- 3.1 This Statement of Common Ground (SCG) has been prepared by Brighton and Hove City Council (BHCC) together with National Highways.
- 3.2 BHCC is the local planning authority for the area, and has the main responsibility for coordinating development and change within the borough. National Highways is the responsible authority for the strategic road network (SRN). BHCC is also the highways authority for the remainder of the road network within the administrative area of Brighton and Hove.

3.4 BHCC has submitted its City Plan Part 2 (CPP2) for Examination in Public, with public hearing sessions expected to take place during November 2021; CPP2 is described further below and, once adopted, will become part of the development plan for the Brighton and Hove area alongside the adopted City Plan Part 1.

APPENDIX A: Proposed Mitigation Measures

Title
**Junction 5 - Devils Dyke
 Proposed Arrangement**

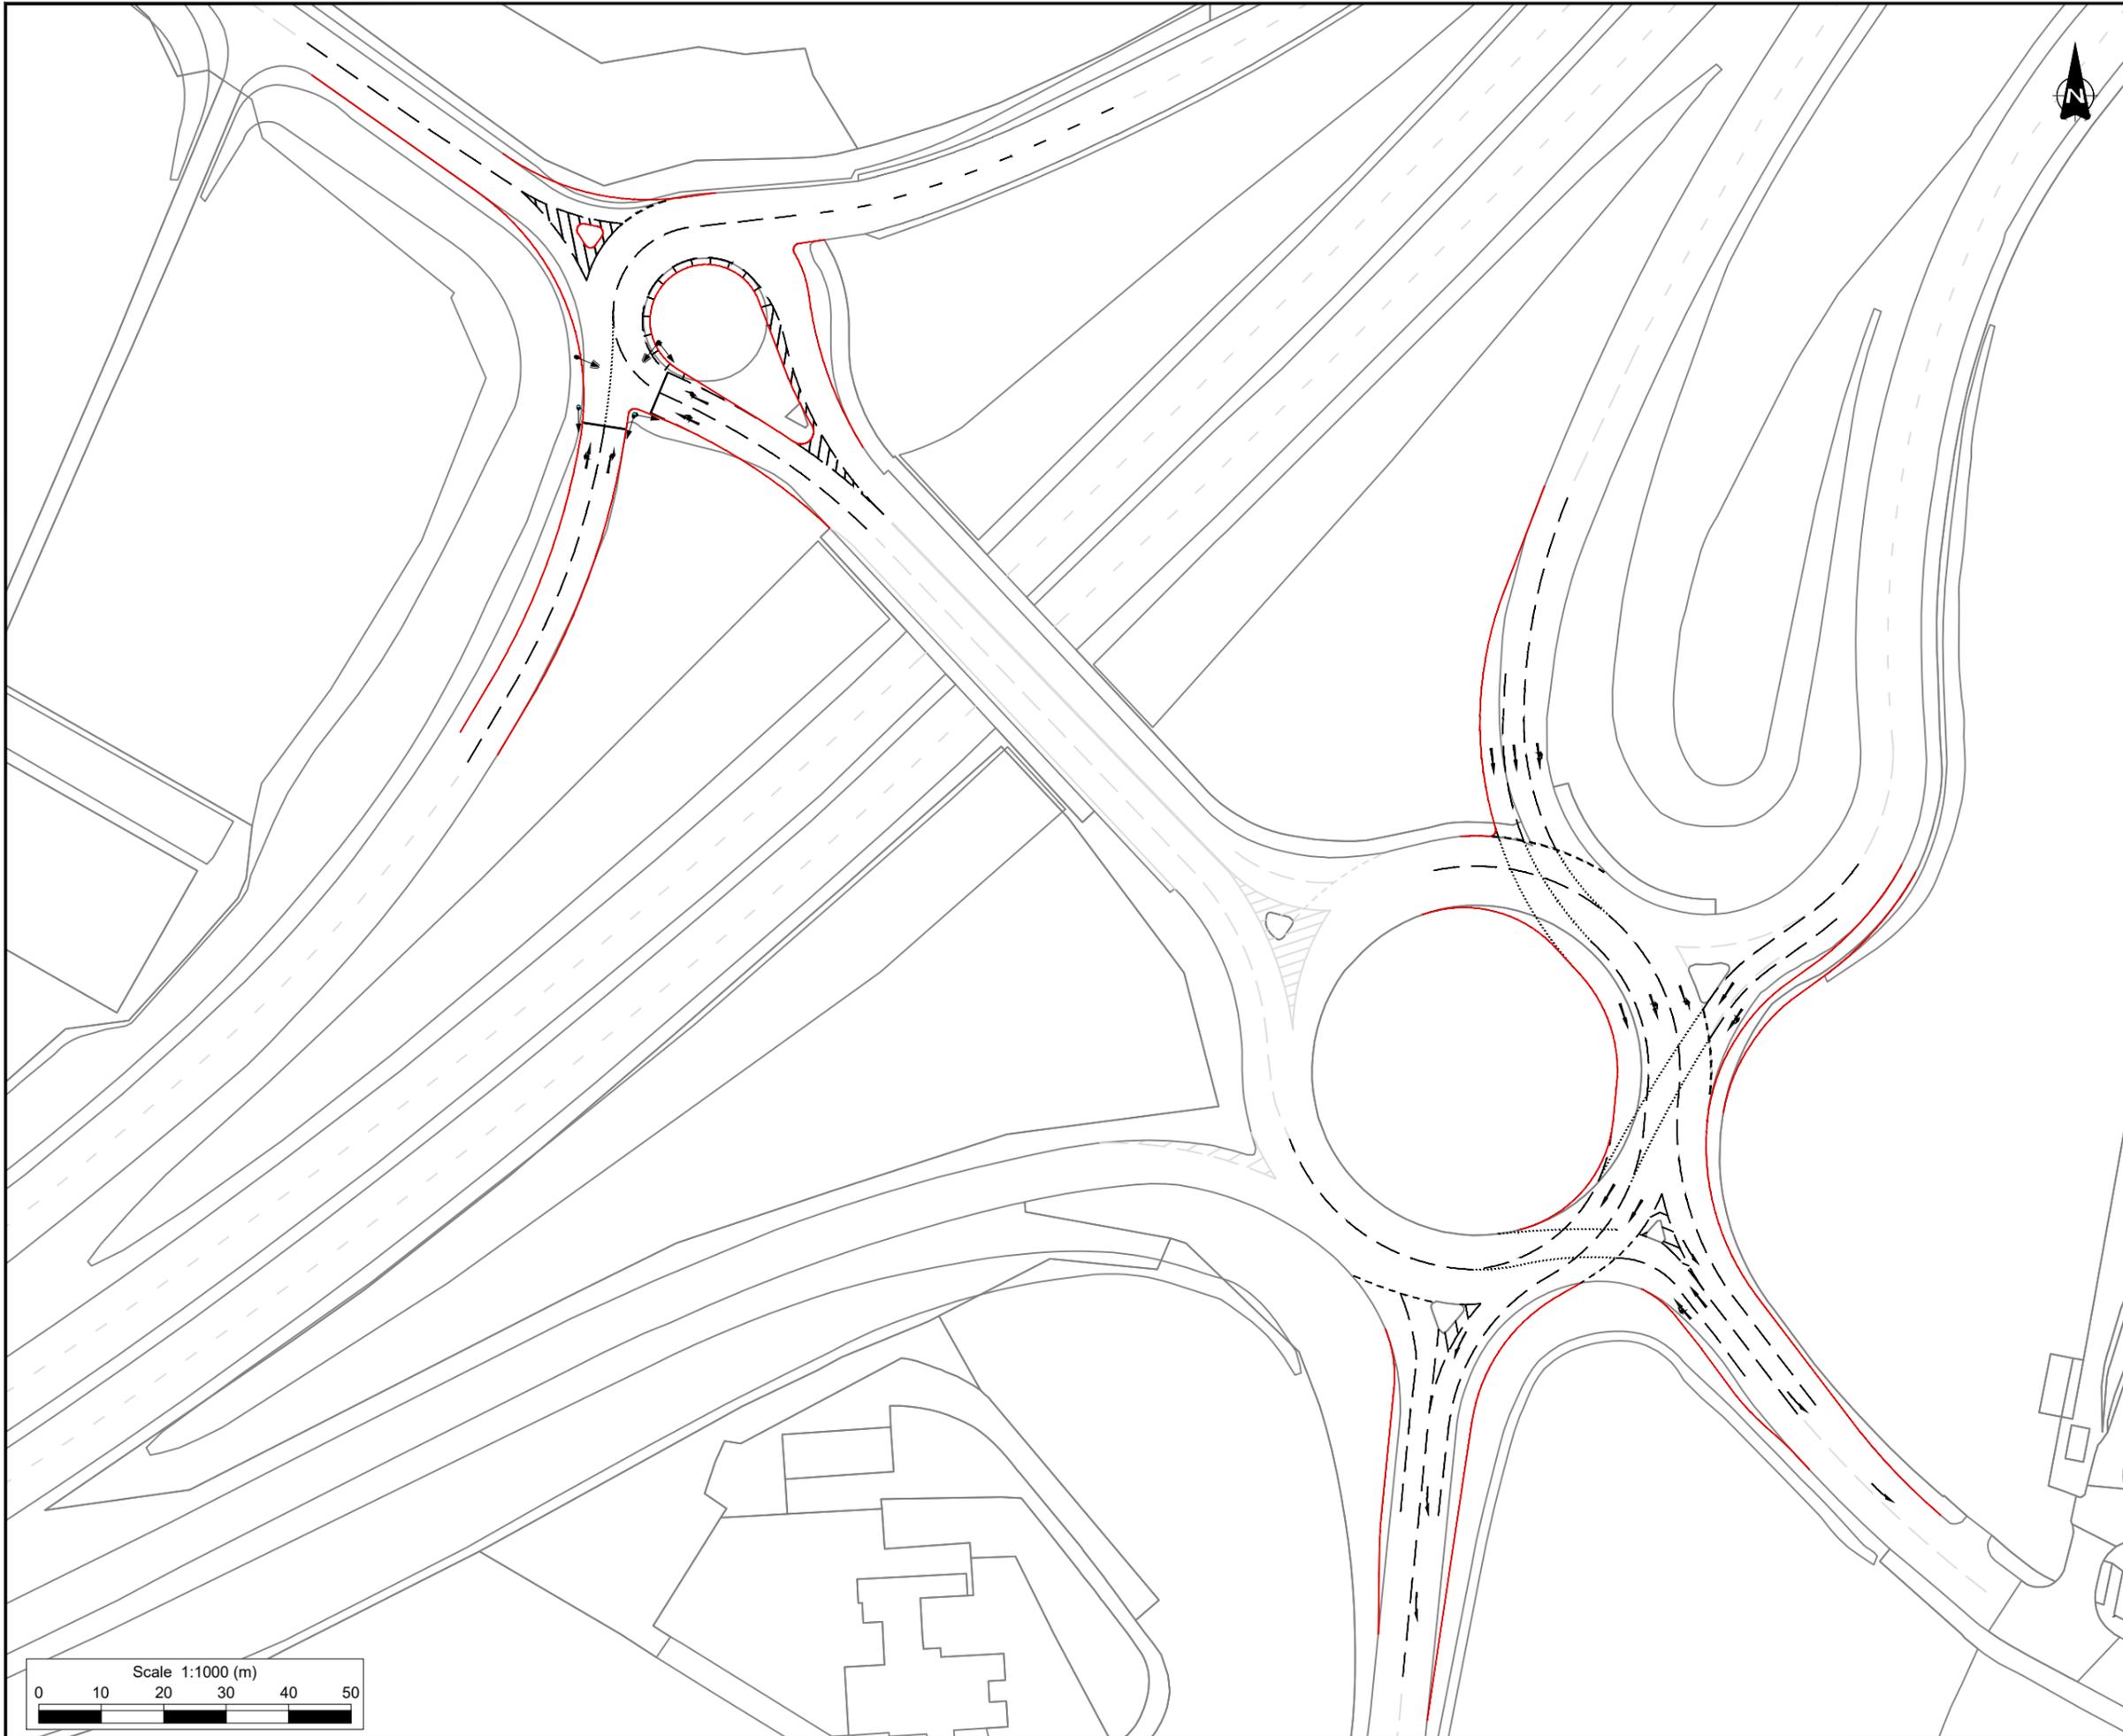
- Junction 5: Requested that the northern part of the junction be modelled as a signalised roundabout and that the two parts of the junction be incorporated into a single model with other minor amendments – SYSTRA response noted the difficulties with accurately representing a non-signalised roundabout within LinSig, and put forward the view that the length of the overbridge (approx. 150m or 22 standard vehicle lengths) had not corresponded to date with excessive queuing toward the roundabouts which would have indicated potential for disruption via blocking back of queues. Clarification was therefore requested with regard to the acceptability of LinSig outputs for the southern part of the junction.

Junction 5 – A27 / King George VI / Devils Dyke Road	The 2030 reference case modelling indicates that there will be extensive queuing and delay at both the northern and southern sides of the junction, with the A27 slip roads showing particular issues in the AM and PM peaks. The addition of CPP2 traffic does not have a material impact upon any part of the junction, but due to the existing issues it is agreed that mitigation of these impacts is necessary to avoid any worsening of the junction's performance, particularly with regard to safety.
Junction 6 – A27 / A293 (Hangleton Link)	The 2030 reference case modelling shows that existing issues with delay and queuing on multiple arms of the junction (northern and southern sides) will worsen, with several arms exceeding 100% DoS in the AM and PM peaks. The addition of CPP2 traffic includes additional impacts to the A27 slips and it is agreed that these impacts require mitigation to resolve.

- 8.11 The drawing of the proposed junction mitigation scheme for Junction 5 is included in Appendix A as drawing reference 109418-dwg-02_A1 (J5 Devils Dyke).

- 8.12 The proposed mitigation scheme includes a number of revisions to junction geometries, including increases to lane widths to improve the overall capacity of the junction.

- 8.13 In the AM peak, the junction as a whole (northern and southern sides) has improved performance compared to both the 2030 reference case and the original 2014 mitigation proposals for CCP1. Whilst the DoS of the A27 Eastbound off-slip remains above 100%, it represents a significant improvement on the 2030 reference case, and also shows reduced queue lengths on the off-slip itself; all other parts of the junction have DoS figures and queue lengths of less than the 2030 reference case, indicating that the specific impacts of CCP2 have been mitigated. In the PM peak, all parts of the junction (northern and southern) have DoS values of 91% or less; this represents a very significant improvement over the 2030 reference case, where multiple junction arms exceed 100% DoS.

Title
**Junction 6 - A27 & A293
 Proposed Arrangement**

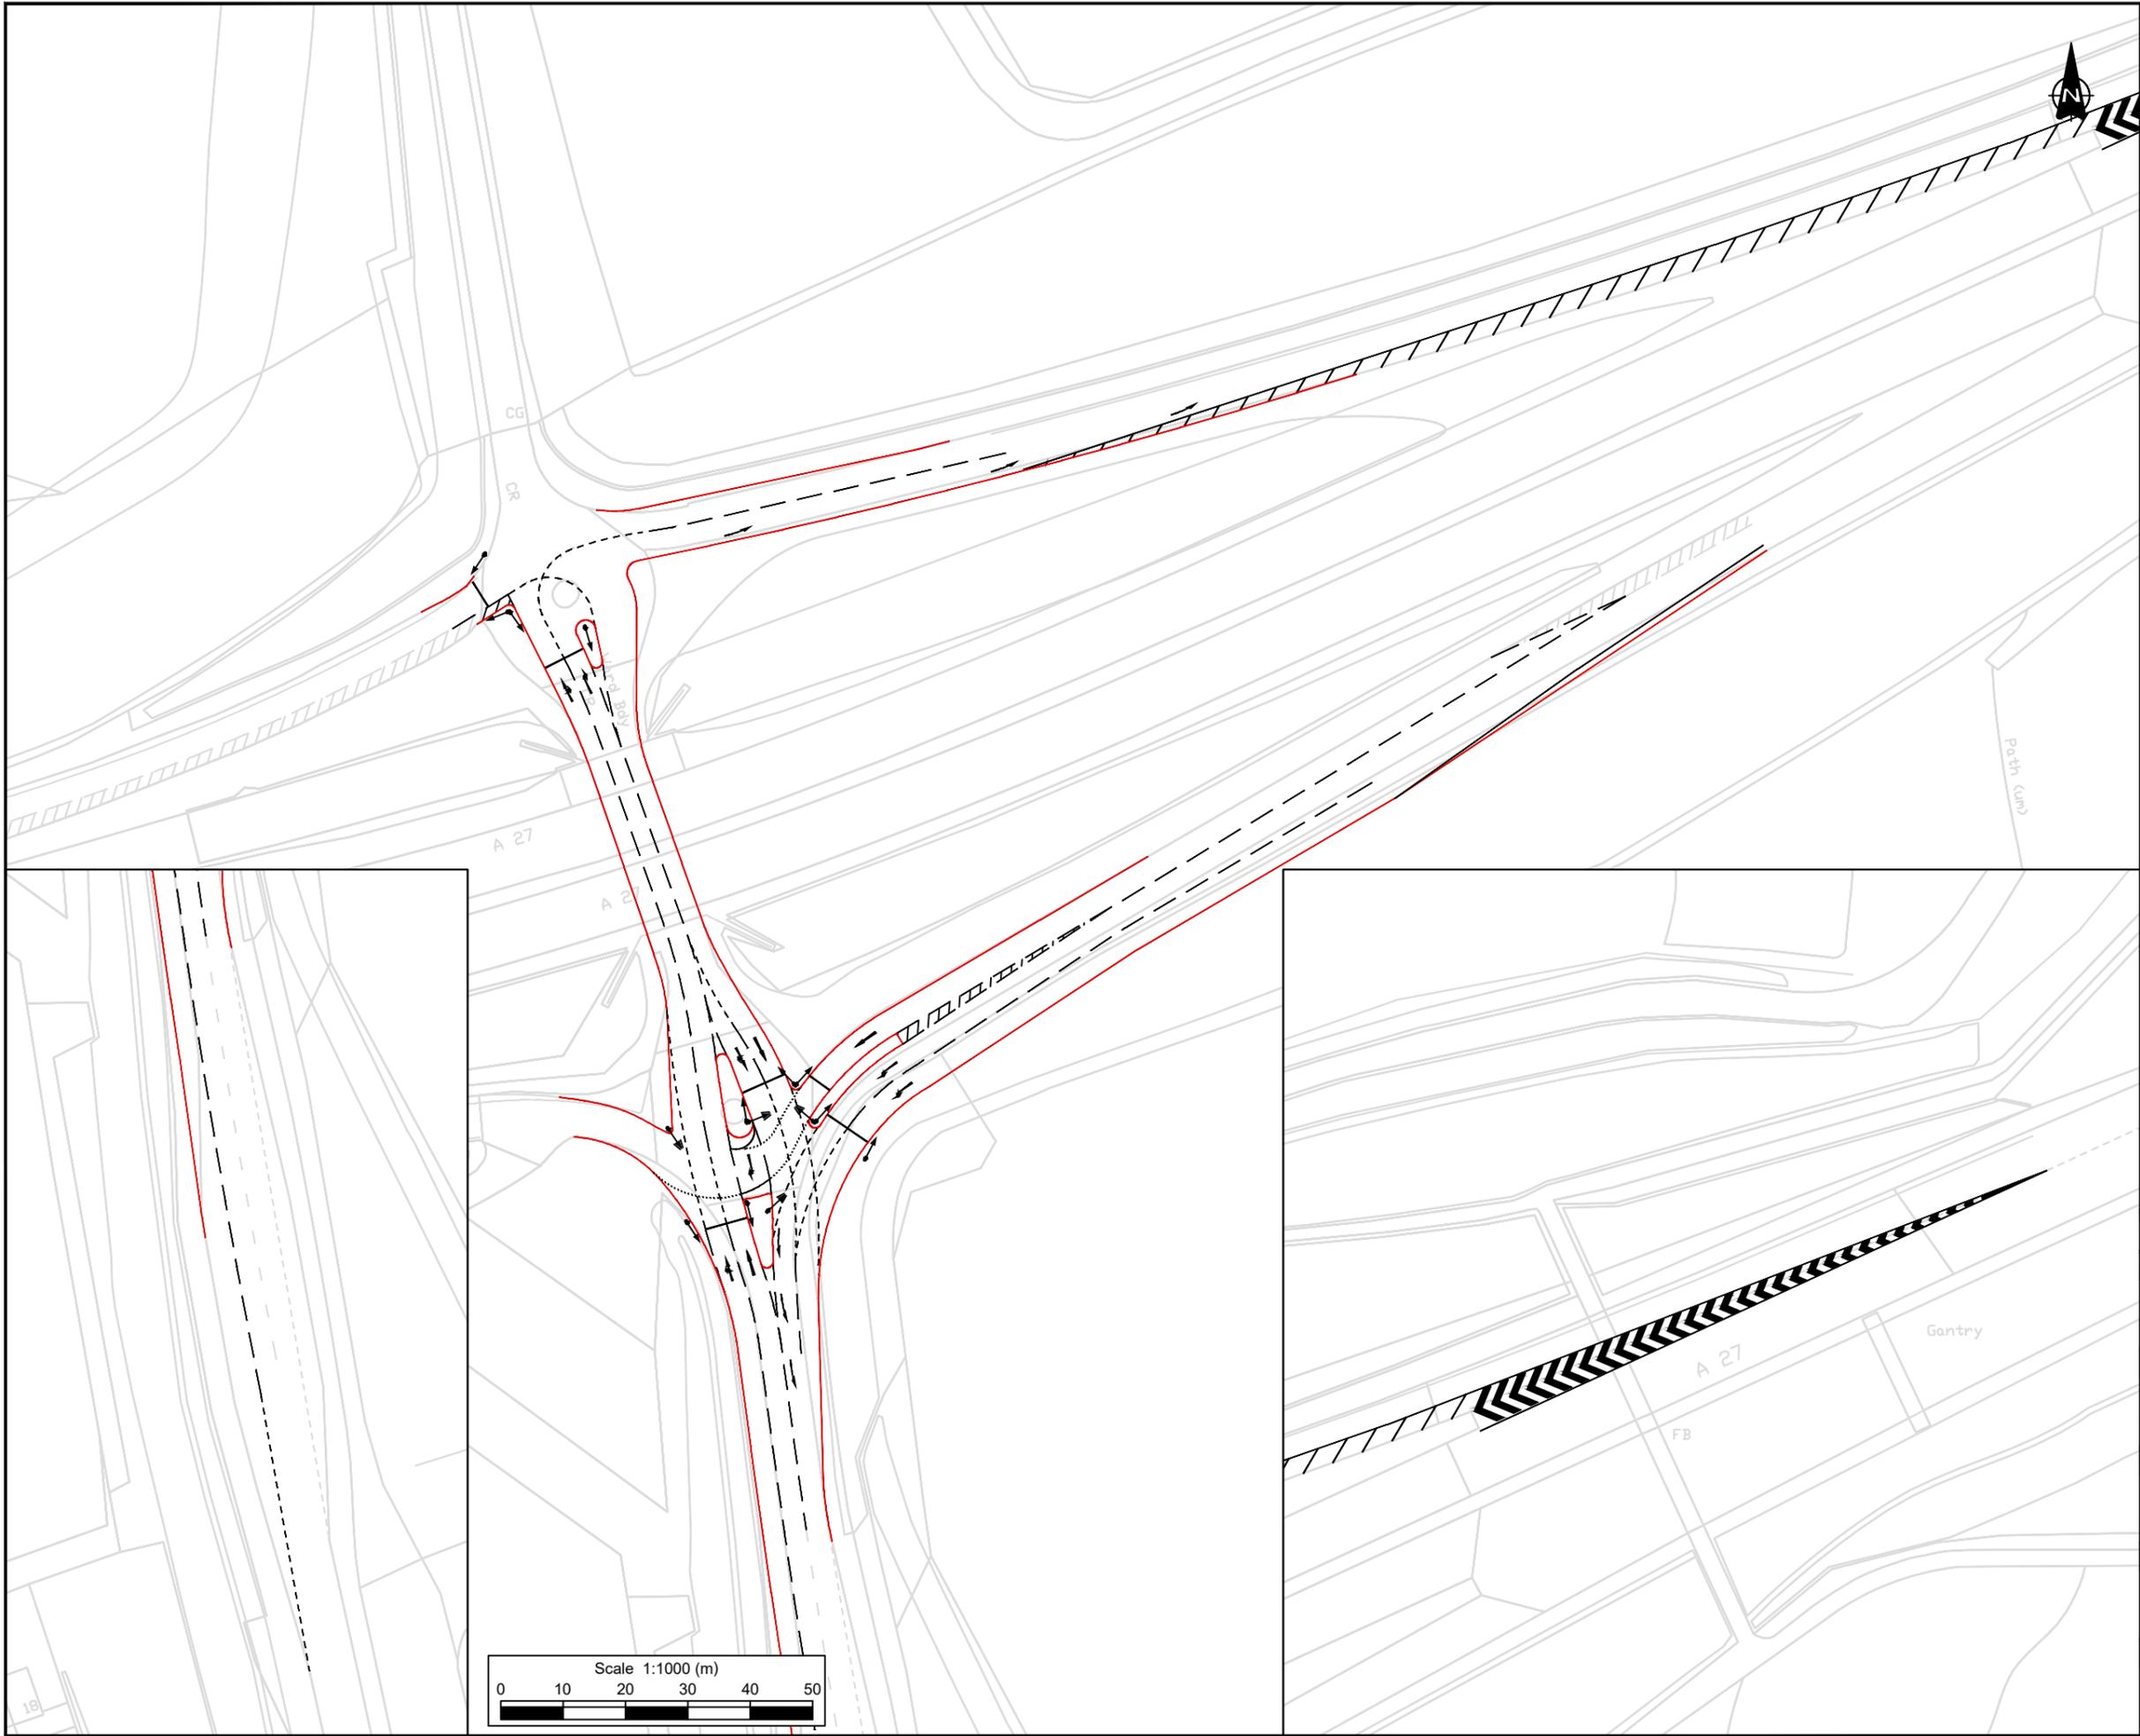
- Junction 6: Requested minor amendments to network layout points, unassigned flows and percentage assignment of flows within lanes on links J2/3 and J2/5 – SYSTRA noted that these changes would be expected to have a limited impact on the model outputs and would not result in any material change to the conclusions drawn.

8.14 The drawing of the proposed junction mitigation scheme for Junction 6 is included in Appendix A as drawing reference 109418-dwg-06_A1 (J6 V3 A27 & A293).

8.15 The proposed mitigation includes amendments to both the physical layout and the signalling arrangement of the junction; this specifically includes provision of a third (splitter) lane to the A27 Westbound off-slip approach to the southern junction and providing two left turn lanes, and revision of the signal phasing of the southern part of the junction to avoid issues with traffic building up on the storage area in the centre of the junction.

8.16 The modelling of the proposed junction mitigation scheme shows that there will be very substantial benefits to multiple arms of the junction; with one exception, all arms are expected to perform at below 90% DoS in the AM Peak (the exception is the A293 south arm, which has a DoS of 92.9). In the PM peak, all arms are expected to perform at or below 90% DoS without exception. Queue lengths in all areas remain within available storage capacities.
